Signalling Protocols and Switching (SPS) - V interfaces at the digital Local Exchange (LE); V5.1 interface for the support of Access Network (AN); Part 1: V5.1 interface specification

AMENDMENT

ETS 300 324-1

**This amendment A1 modifies
the European Telecommunication Standard ETS 300 324-1 (1994)**

Figure 1a: Mask of the pulse at the output port of the layer 1 interface

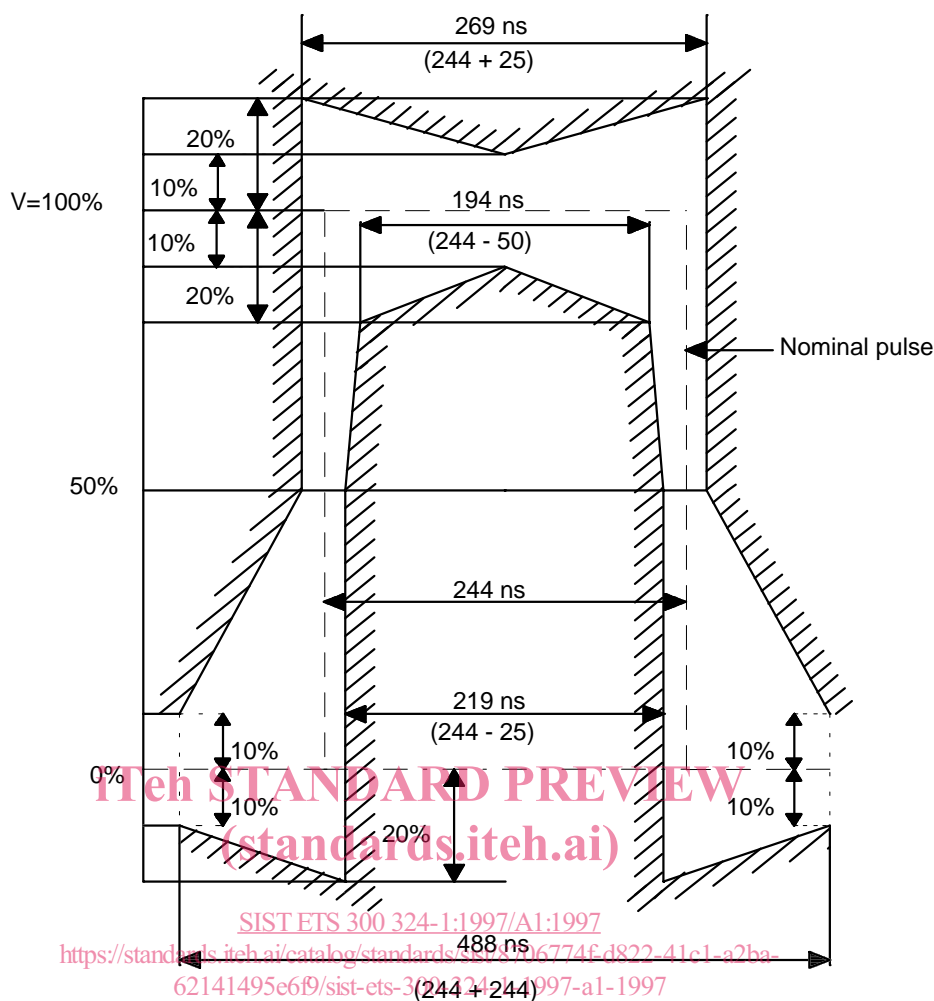
- d) The pulse mask given in figure 1a (which is based on figure 15/G.703) shall be met at the output port of the layer 1 interface with the amplitude values as defined in table 0a, item h).

Figure 1b: Pulse generator 1,2/50 μ s for differential mode voltages

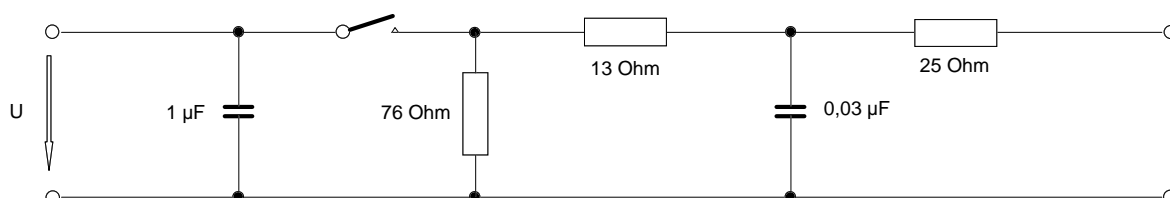
- differential mode: with a pulse generator as defined in figure 1b (which is based on figure B-1/G.703), no test value is specified;
- common mode: with a pulse generator as defined in figure 1c (which is based on figure B-2/G.703), U = 100 Vdc.

Figure 1d: Lower limit of maximum tolerable input jitter and wander

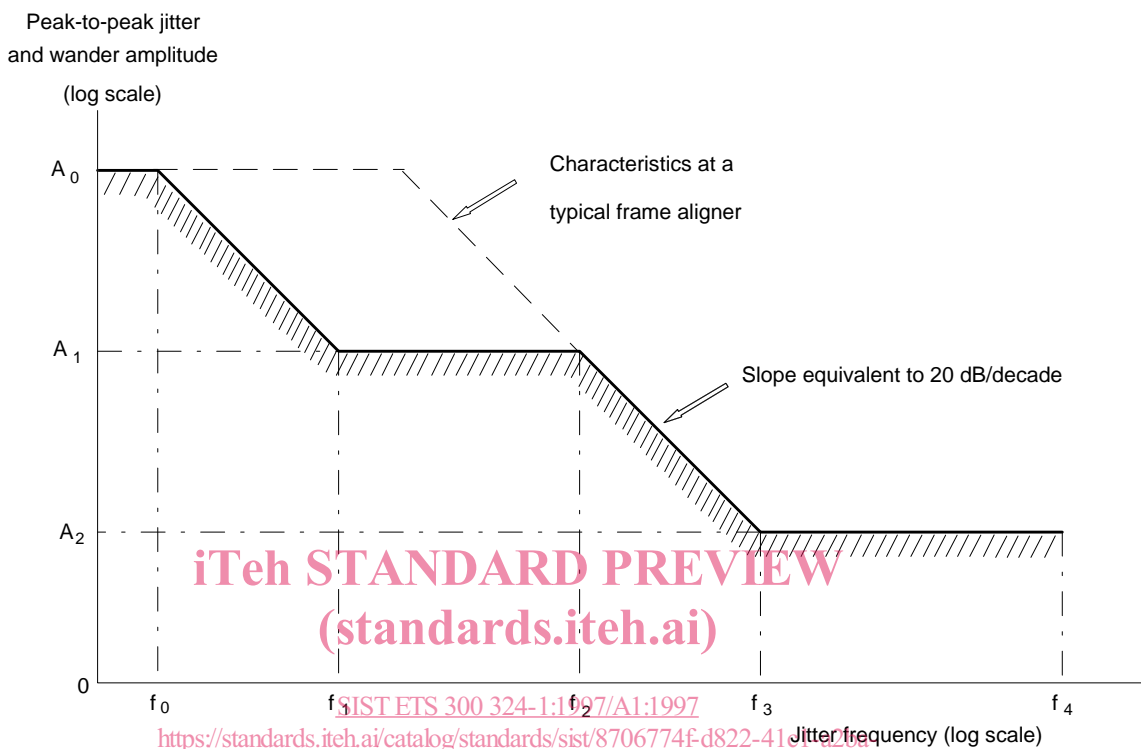
- m) The output port of the layer 1 interface shall meet the output signal balance requirement, which shall be measured in accordance with CCITT Recommendation O.9 [8], subclause 2.7:
- 1) at 1 024 kHz: ≥ 40 dB;
 - 2) 1 024 kHz to 30 MHz: minimum value decreasing from 40 dB at 20 dB/decade.
- n) The output port of the layer 1 interface shall meet the jitter and wander requirements defined in figure 1d and table 0d.
